Major sustainable transport deficiencies (in the development)

This appendix briefly outlines our main concerns with the development regarding sustainable transport which go beyond the loss of the Sussex Pad crossing and include the poor level of sustainable infrastructure within the development:

Sussex Pad Crossing – The Facts

Diversions and time delays

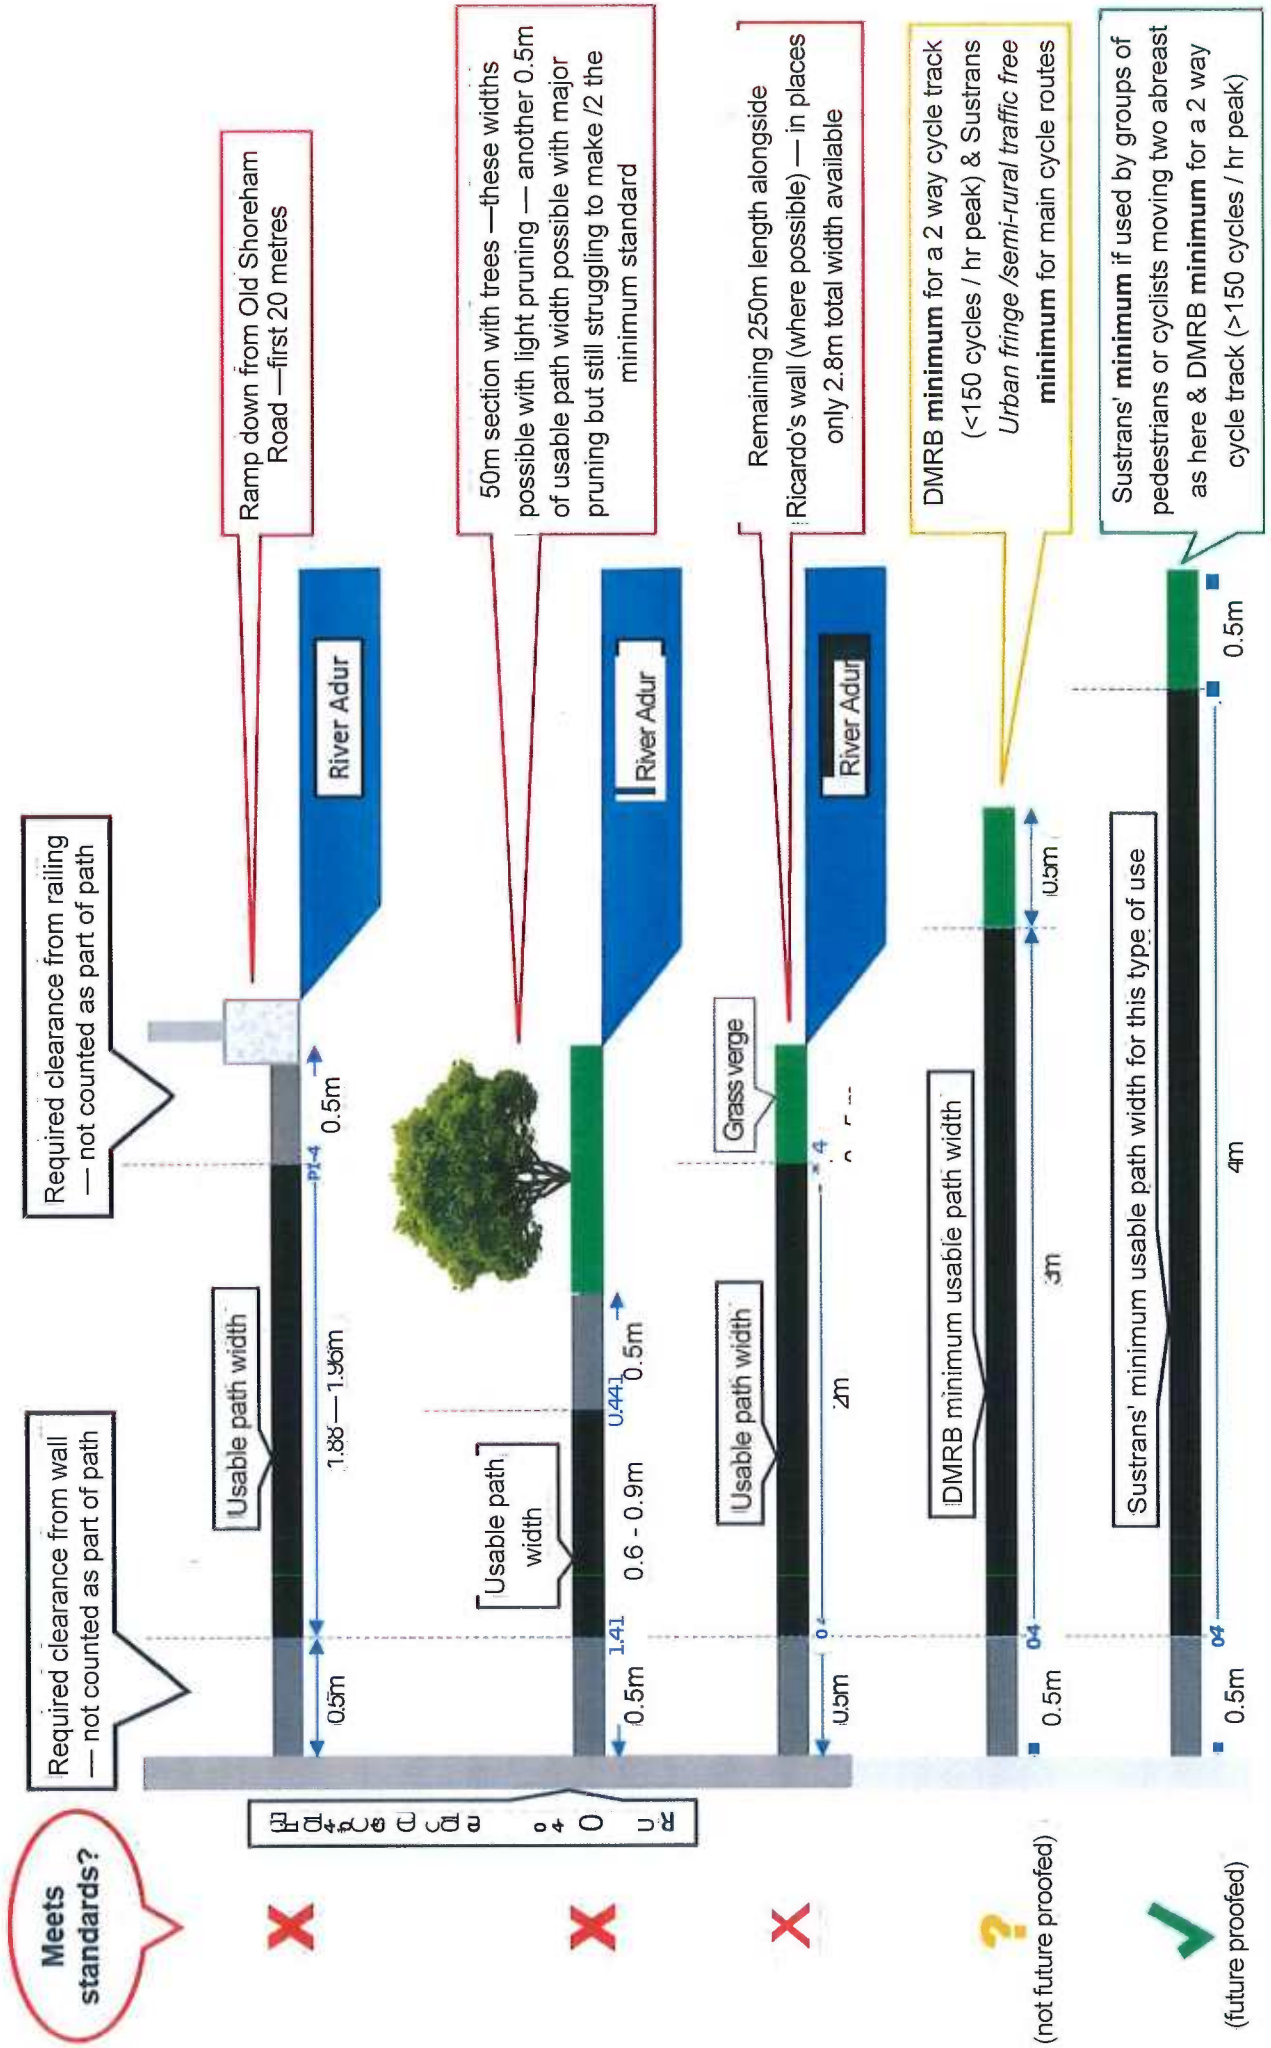
Diversion (metres) / time to use by cyclists (seconds)			Meets standards?	Capacity	Safe	Grade separated?
	From west (Lancing)	From south (airport)	From east (Tollbridge)				
Sussex Pad on road (1 stage)	0m / av 79 secs	0m / av 79 secs	0m / av 79 secs	Yes	High	Yes	No
Sussex Pad crossing (2 stages – but possible to cross in one)	0m / av 79 secs	0m / av 79 secs	0m / av 79 secs	Yes	Med	Yes	No
New bridleway alongside river	1,160m / 213 – 324 secs* (with an improved path from the housing this would be an option)	740m / 138 -207 secs*	330m / 62 secs (unlikely) – 92 secs (realistic)*	No	Low	No	Yes
Roundabout (4 stage crossing)	150m / 42 secs** for diversion & up to 240 secs for four crossings (assumed 120 secs crossing delay)	Unlikely to be used	Unlikely to be used	No	Med	Yes (unless riders get frustrated at waiting)	No
Fastest route (by how much)	Sussex Pad (by approx. 83 – 245 secs)	Sussex Pad (by 59 – 128 secs)	Sussex Pad (by 13 secs)

* It is unlikely cyclists would travel at 12mph on the new bridleway as there is a 90 degree tight turn onto it with bollards, its narrowness, tight bends plus other users, all of which would slow them down. They may also have to wait to join Coombes Road. Therefore, times are given for cycling at 8mph (the more realistic speed in this situation) as well as 12 mph (used by the consultants). More cautious and less confident cyclists would travel even slower than this.

Diversion (metres) / time to use by pedestrians (seconds)			Meets standards?	Capacity	Safe	Grade separated?
	From west (Lancing)	From south (airport)	From east (Tollbridge)				
Sussex Pad crossing (2 stages – but possible to cross in one)	0 / av 131 secs	0 / av 131 secs	0 / av 131 secs	Yes	Med	Yes	No
New bridleway alongside river	Unlikely to be used	740m / 529 secs	330m / 236 secs	No	Low	No	Yes
Roundabout (4 stage crossing)	150m / 107 secs for diversion plus up to 240 secs for four crossings (assumed 120 secs crossing delay)	Unlikely to be used	Unlikely to be used	No	Med	Yes (unless get frustrated at waiting)	No
Fastest route (by how much)	Sussex Pad (by 96 secs)	Sussex Pad (by 398 secs)	Sussex Pad (by 105 secs)

New brideway path widths (along River Adur) compared to minimum standards

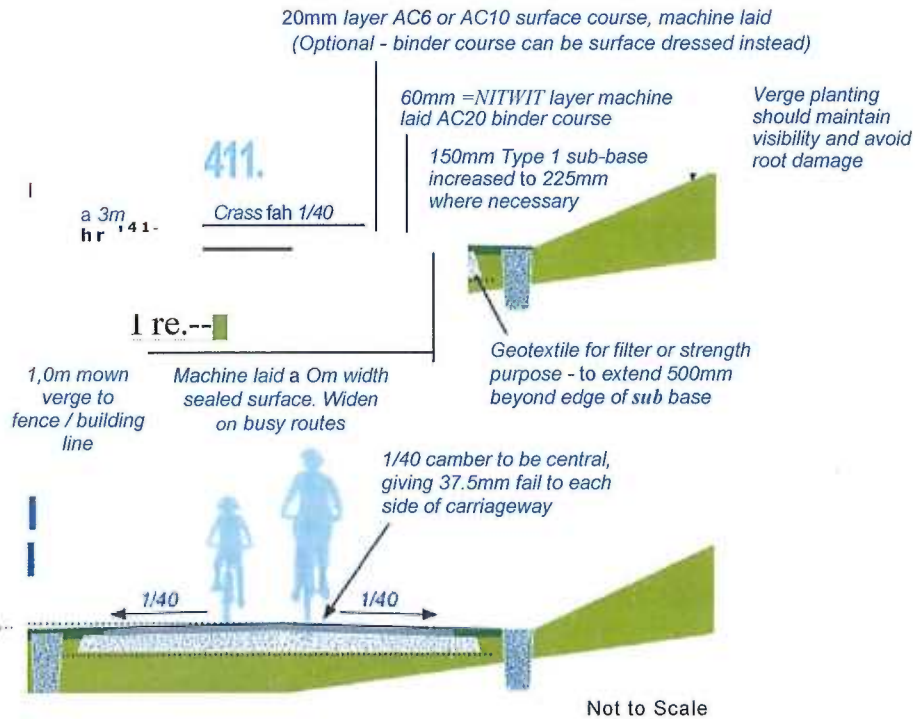
Unfortunately, none of the above are true, apart from possibly the first one. Even then it is misleading as it doesn't represent the usable path width, which is a maximum of 2 metres and often less given the narrow width of the river bank. This is best shown by the accompanying diagram (see Appendix 7) which illustrates the varying usable path widths against the two standards being quoted, including any mandatory clearances from walls and other obstacles which the developers failed to include.

In relation to point 2, having done a survey measuring the size of the top of the bank in seven places along the path, it is clear that the width available is mostly less than 3.5m and for a number of sections it is under 3 metres, down to as low as 2.8 metres. With the trees there is even less room. This demonstrates that with the required clearance from the wall and a safety buffer to the edge of the river, this path can never be wide enough to meet even minimum design standards, unless there is a severe incursion into the River Adur and the Site of Special Scientific Interest, or a bridge / pontoon structure is built above the existing path and river.

When the peak hour rate is above 150 cycles an hour, then Table 2.2.11 states that a 4 metre minimum usable width is required. Therefore, to allow for further growth in cycle use in line with the Government’s ambition to double cycling by 2025, the path should be built to accommodate 214 cycle per hour (peak use). This means that a 4 metre path (usable width) should be used (in a 5m clear corridor) as a replacement for the Sussex Pad crossing.
